Re: NLH Proposal for Network Addition Policy and Transmission Expansion Plan – Labrador Interconnected Group RFIs LAB-NLH-073 to LAB-NLH-109

IN THE MATTER OF the proposed Network Addition Policy and Labrador Transmission Expansion Plan

Requests for Information

LAB-NLH-73 to LAB-NLH-109

Figure 6: Projected Rate Increase vs. Capital Investment

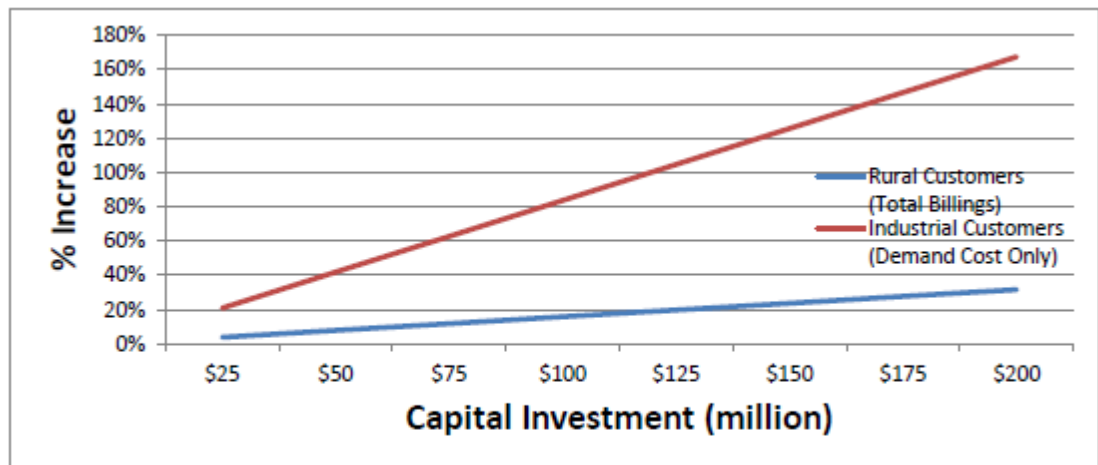
Figure 6 suggests a linear relationship between capital investment and rate increases. However, given that the transmission expansion projects selected in the study are large and “lumpy”, the relationship between load increases and rate impacts does not follow a straight line.

Please present block graphs, separately for Labrador East and Labrador West, that indicate:

- On the x-axis, peak load,
- On the left y-axis, capital expenditures for transmission infrastructure required to meet the peak load on the x-axis, and
- On the right y-axis, the % rate increase for rural customers resulting from those investments.
